Addendum No. 1 to Mitigated Negative Declaration

Cactus Avenue Corridor Groundwater Wells Project

State Clearinghouse #2020030267

Figure 1-2: Modified Project (Approved Project and Modified Elements)

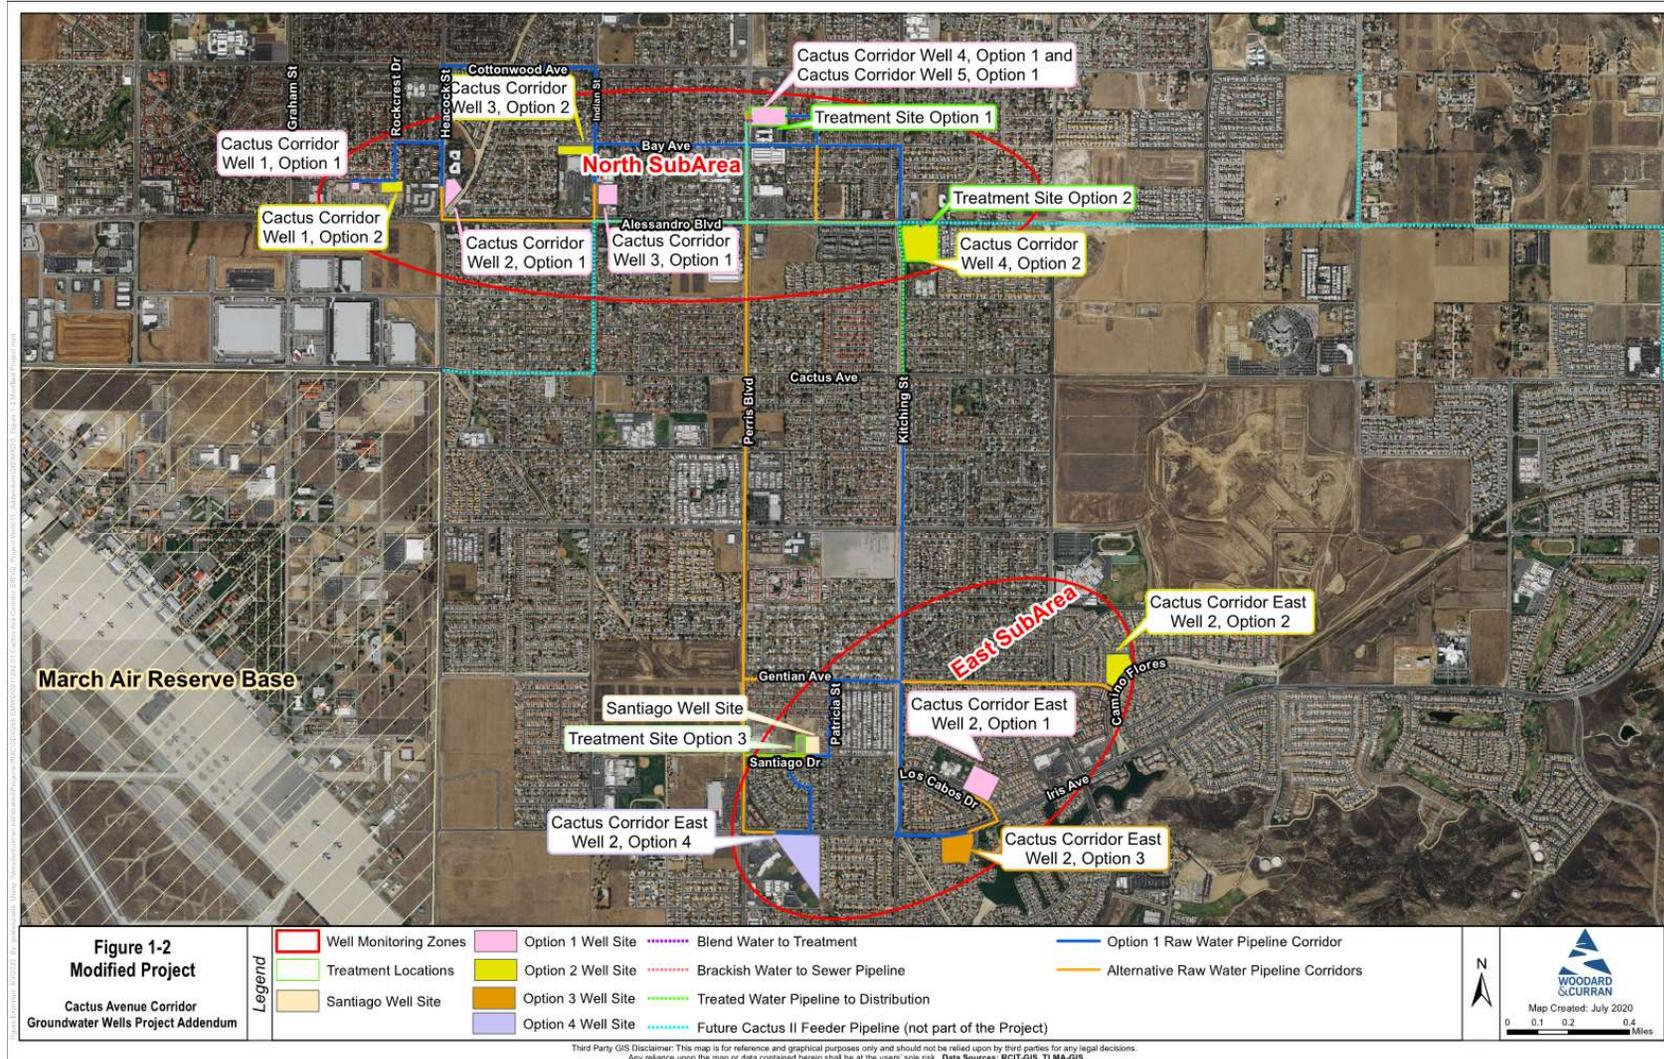
The Modified Project would result in the construction of an additional well on an EMWD owned site located on the east side of Perris Boulevard north of Bay Avenue. Construction of this well would raise the overall number of Project wells to seven. This site is also the proposed site for Treatment Plant Option 1 and Cactus Corridor Well 4, Option 1. The additional well, “Cactus Corridor Well 5, Option 1” would be similar in size and depth to Cactus Corridor Well 4, Option 1 and would be constructed in a manner consistent with the other extraction wells in the North Sub-Area. **Figure 1-2** and **Figure 1-3** show the proposed location for this new well.

Figure 1-2 shows the proposed Modified Project together with the Approved Project, while **Figure 1-3** shows only components of the Modified Project that differ from the Approved Project.

Figure 1-3: Changes from the Approved Project in the Modified Project

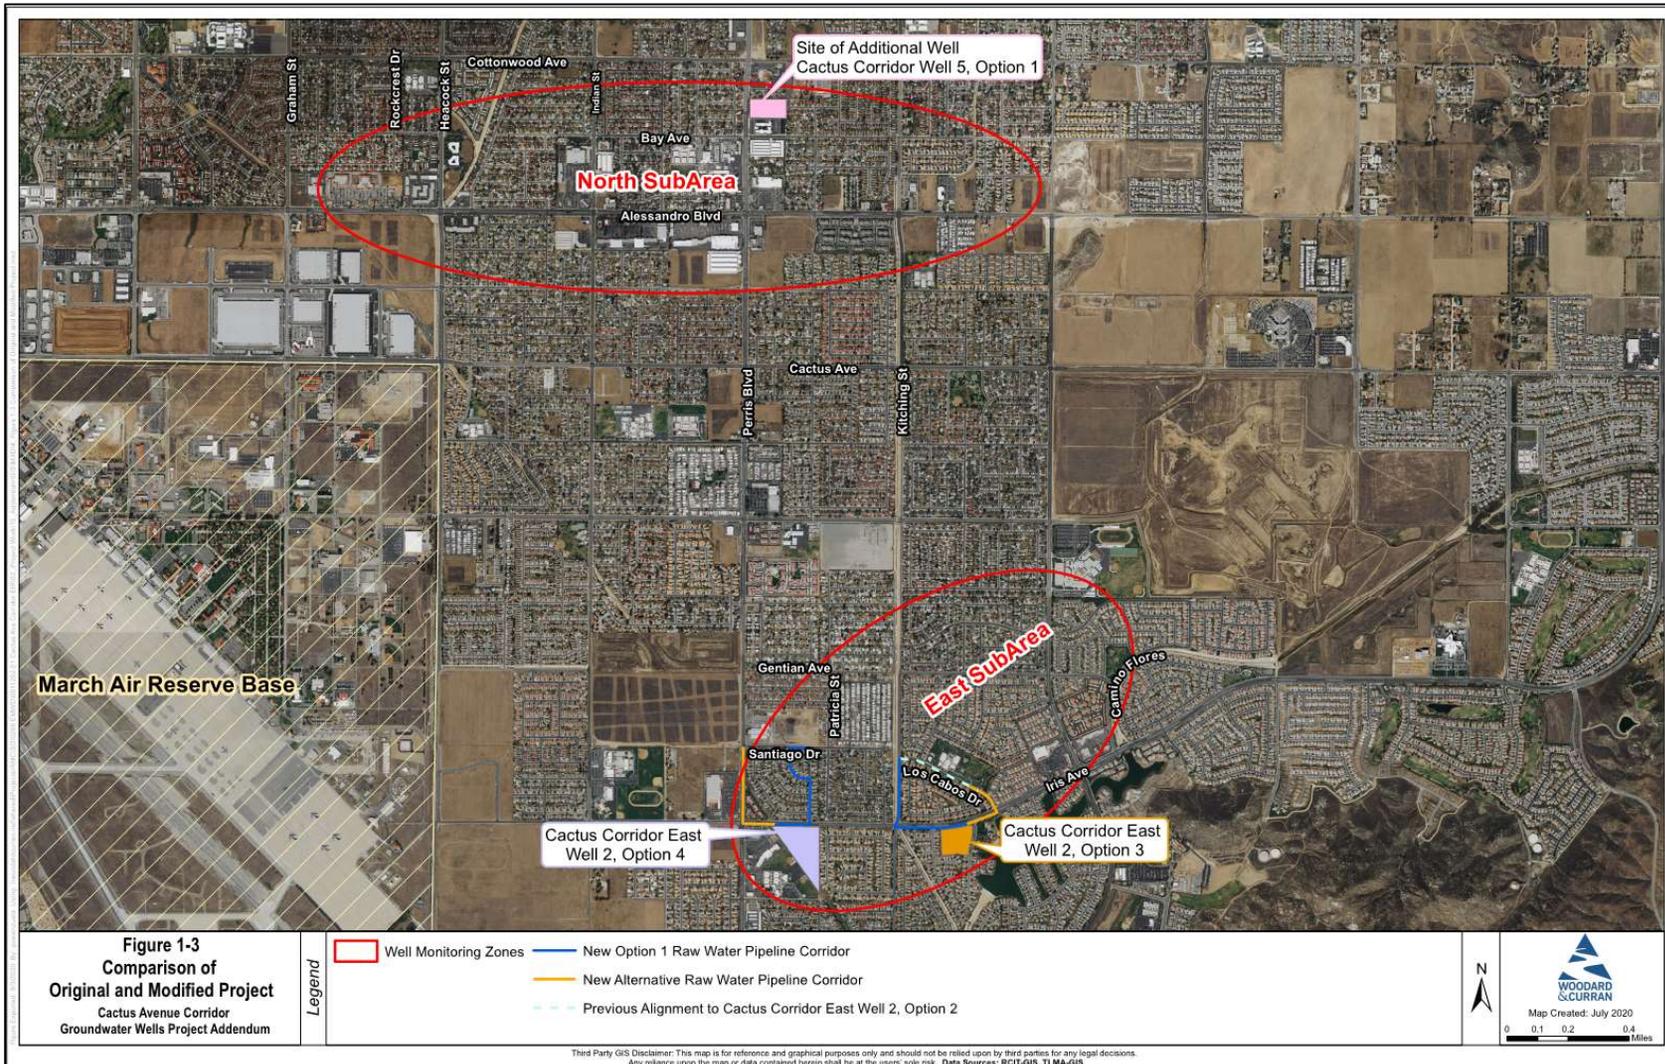
A revised pipeline alignment for the Victoriano Park well option (CCE Well 2, Option 1) is also proposed in the Modified Project. Instead of the approved in-street pipeline alignment from Victoriano Park northeast within Los Cabos Drive to Kitching Street (where it would tie into existing water infrastructure), the Modified Project’s alignment would redirect the pipeline southeast within Los Cabos Drive to Iris Avenue, and then west within Iris Avenue to Kitching Street, and then north within Kitching Street to tie into existing water infrastructure near the Kitching Street/Los Cabos Drive intersection.

In total, the revised pipeline alignment represents an overall increase in pipeline length of 2,219 linear feet if Victoriano Park (CCE Well 2, Option 1) is selected, an increase in 962 linear feet if Pedorena Park (CCE Well 2, Option 3) is selected, or an increase in 1,045 linear feet if the Iris Avenue/Wedow Drive site (CCE Well 2, Option 4) is selected. No changes would occur if Parque Armistad (CCE Well 2, Option 2) is selected.
